I am writing to provide a response regarding the Ventura West Dock Upgrade package discussed in the November 2024 VPD Board Meeting and up for approval at this meeting. Space limitations (1000 characters) require a significant downscaling of the data and analysis conducted. I have the complete work, with all supporting analysis, should staff or the Board wish to review it in more detail. I am also happy to review this in person, if desired.

Public Comment Re: Agenda Item: Standard Agenda Item 1

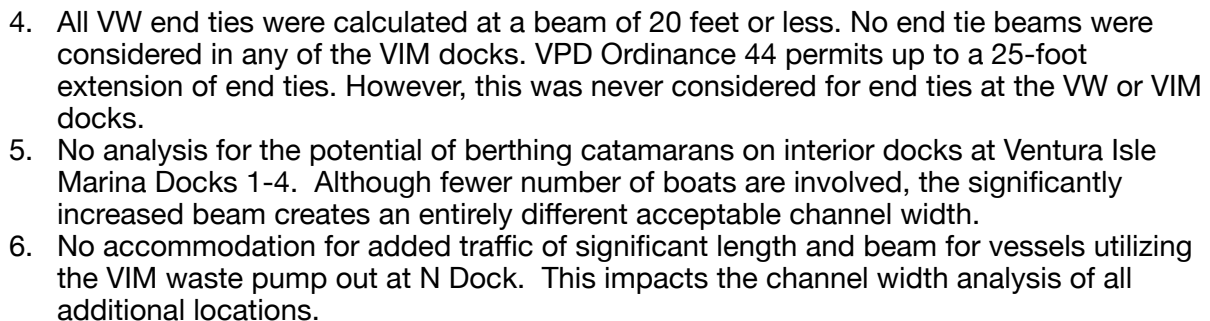
After reviewing the Nobel analysis, I have concluded that, despite the review by the staff, it may contain inaccuracies that warrant reconsideration. These points are pertinent to the channel clearance analysis for the area between Ventura West (VW) slips and the Ventura Isle Marina (VIM) slips. I have attached a spreadsheet that highlights these areas and would like to point out that at several points in the analysis, minimum ASCE recommended channel clearances are not met, which contradicts the Nobel conclusions presented at the November Meeting.

Channel width requirements are based on either the ACSCE Manual 50, which requires 5 times the average beam of vessels using the area plus 10% of the total number of boats transiting, or the California Department of Boating and Waterways Channel Design criteria, which stipulates a bottom channel width of 75'. The Nobel analysis includes boats docked, but makes no assessment of vessels transiting due to pump out access or public launch access at both VIM and VW.
